HAMPEL ADDITION

TO WICHITA, SEDGWICK COUNTY, KANSAS

Re: S/D 95-53 HAMPEL ADDITION (Final Plat)

STAFF REPORT

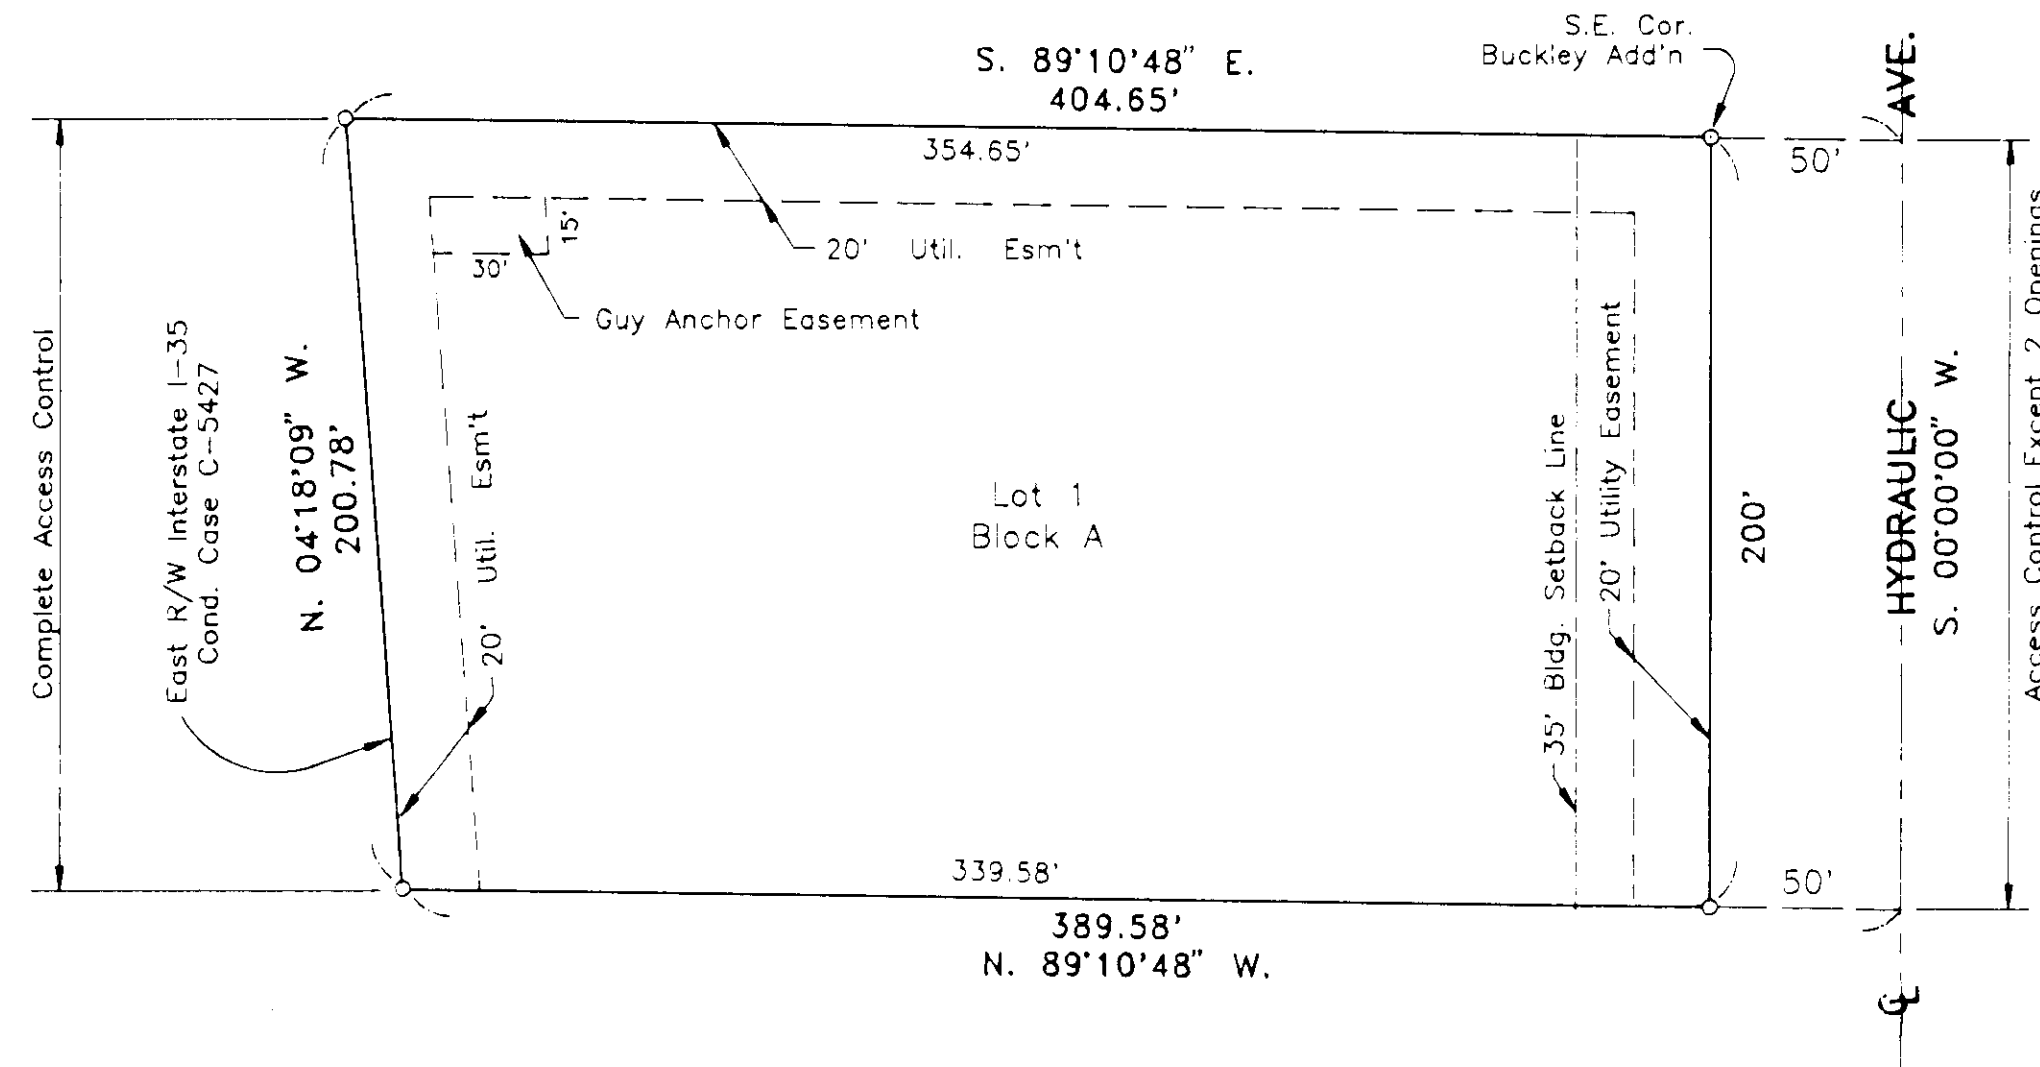
- ~~D.~~ On the final plat tracing, the word "complete" shall be deleted on the face of the plat where access control to Hydraulic is shown.
- ~~E.~~ The applicant shall install or guarantee the installation of all utilities and facilities which are applicable and described in Article 8 of the MAPC Subdivision Regulations. (Water service and fire hydrants required by Article 8 for fire protection shall be as per the direction and approval of the Chief of the Fire Department.)
